Following on from your attached email, for reference, please see email below from Scott Castle of Acoustic Associates (who produced the Noise Report submitted with applications LU/193/19/DOC & LU/194/19/DOC) to Carol Reynolds in response to comments made by Environmental Health.

Subject: 22 Beach Road, Littlehampton.

I write further to the client providing me with your feedback on the AASL acoustic report dated 6th June 2019 for the above site.

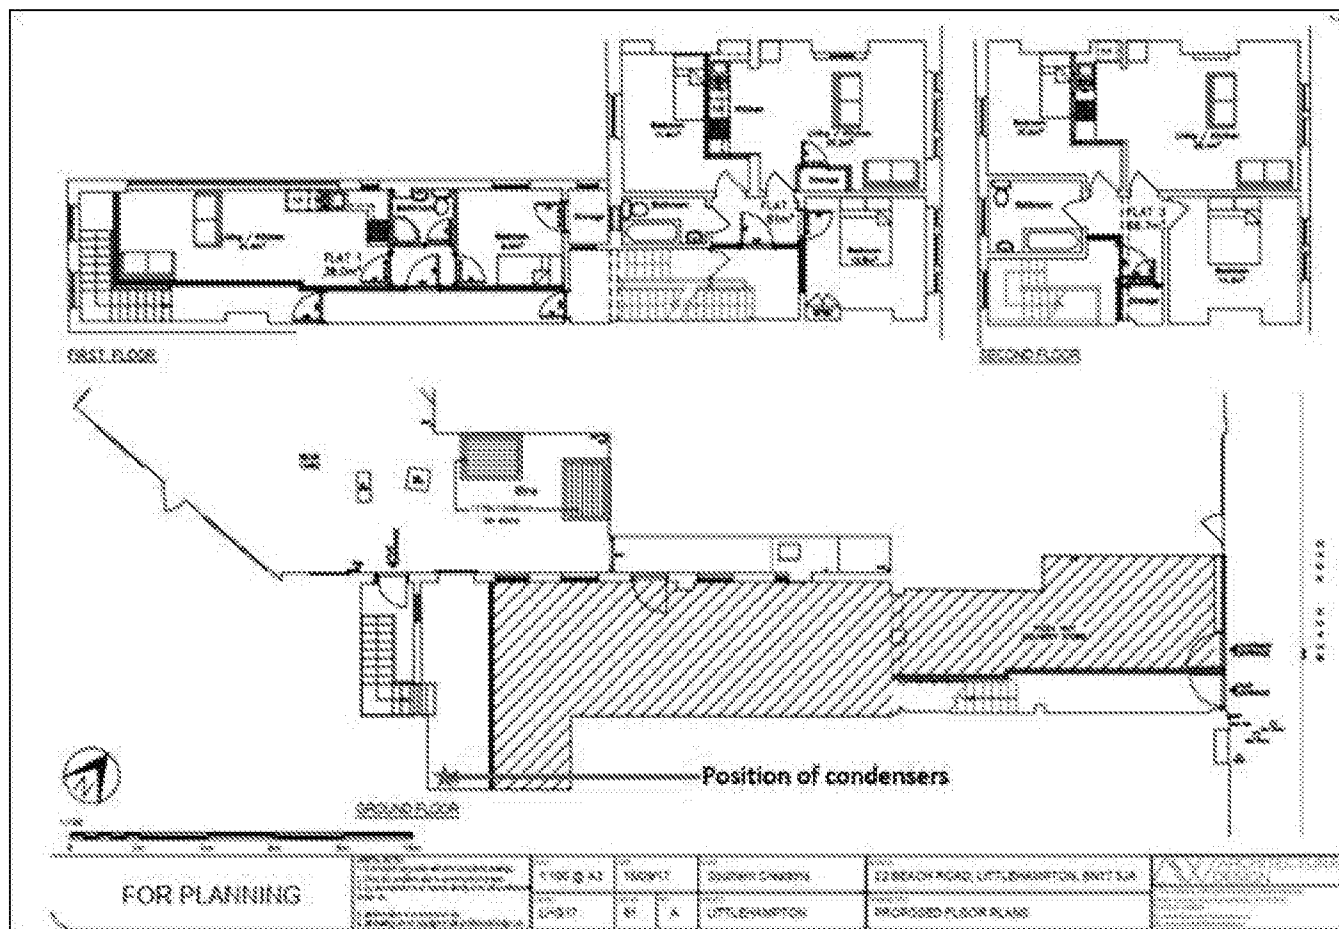
A site photograph below shows the existing ductwork and importantly that the termination point is well away from the bedroom window and above eaves. Whilst present on site, Flat 3 was visited and subjectively listened to, before determining where to set up the various survey instruments. The rationale behind the selection of survey positions was already detailed within the report.
